Attachment 7-13 WSP Parsons Brinckerhoff -
Independent review of Flemington development
strategy

FLEMINGTON ZONE SUBSTATION

INDEPENDENT ASSESSMENT OF SUPPLY
CAPACITY LIMITATIONS

Final Report

Figure 4-1 Forecast summer loading against 'N-1' station ratings

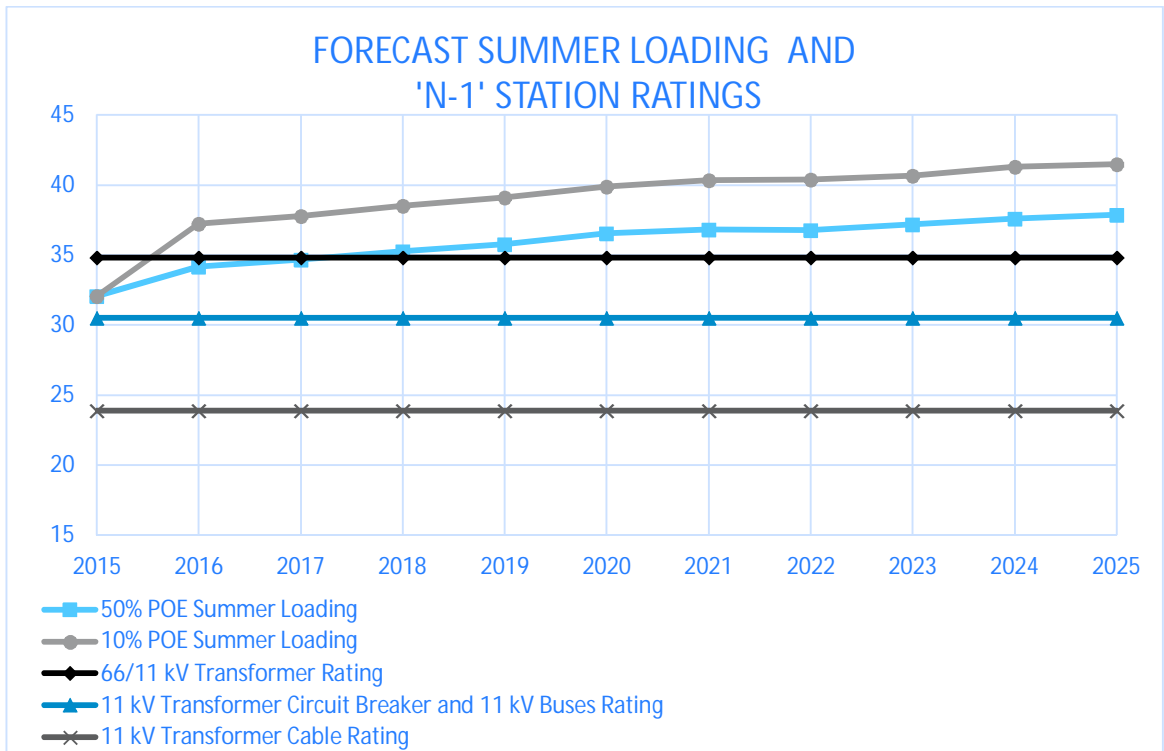
Demand on the Flemington Zone Substation is forecast to grow at an average rate of 1.9% per annum over the next 10 years. The forecast demand at FT for 50% Probability of Exceedance (POE) and 10% POE maximum demand conditions is presented in Figure 4-1, based on JEN’s

Load Demand Forecasts 2015. Key station asset ratings are also presented in Figure 4-1 and Table 4.1 to demonstrate the limiting assets. It can be seen that the 66 /11 kV transformer rating of 34.8 MVA has sufficient capacity to meet the 50% POE forecast maximum demand until 2017 with load at risk from 2018 onwards. However, other key assets (11 kV transformer cables at 23.9 MVA and circuit breaker and the 11 kV buses at 30.5 MVA) currently limit the capacity of FT to below the current and forecast demand conditions, resulting in considerable load at risk and expected unserved energy under system normal and network outage (N-1) conditions as discussed in section 4.1.4.

In summary, the Flemington zone substation 66 / 11 kV transformer rating of 34.8 MVA has sufficient capacity to meet the 50% POE forecast maximum demand until 2017 with load at risk from 2018 onwards, however capacity is currently limited under system normal and outage conditions by the:

- 11 kV transformer cables at 23.9 MVA and
- 11 kV circuit breakers and buses at 30.5 MVA

Figure 4-2 Optimal timing of options

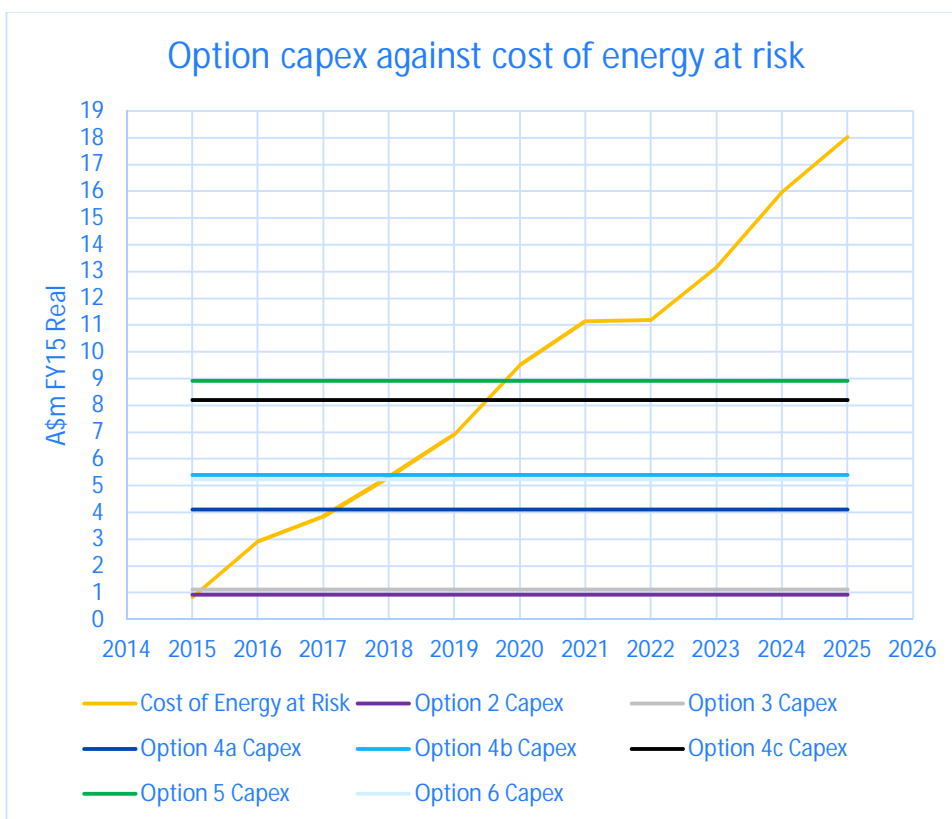
Optimal timing of options has been determined by comparing the capex of each option against the cost of expected unserved energy should no augmentation occur for that year to determine the point where the cost benefit outweighs the capex, shown in Figure 4-2.

Figure 4-3 Energy at risk as a result of capacity constraints and reliability degradation

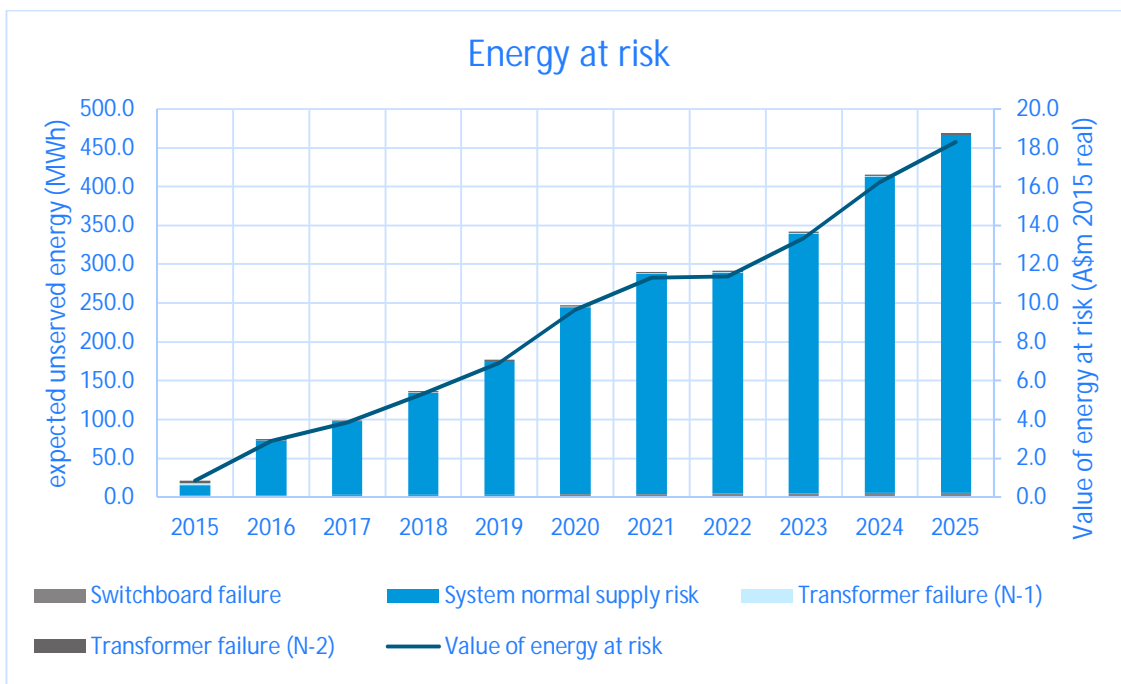
In WSP | Parsons Brinckerhoff’s opinion, replacement is not necessary in the 2016–20 period to maintain network reliability, safety or security. The primary driver is to address forecast capacity constraints. Replacement is considered as the prudent option, given that the assets will shortly be due for replacement and that a non-like for like replacement will address the forecast capacity constraints. This approach results in minimal life cycle costs, as is demonstrated by the NPV analysis of the viable options.

When both insufficient capacity to meet increasing demand and declining reliability as a result of aged assets are taken into consideration the energy at risk under the current conditions is considerable as shown in Figure 4-3. Figure 4-3 also demonstrates that the system normal supply risk alone, due to capacity limitations, is sufficiently high to justify augmentation.
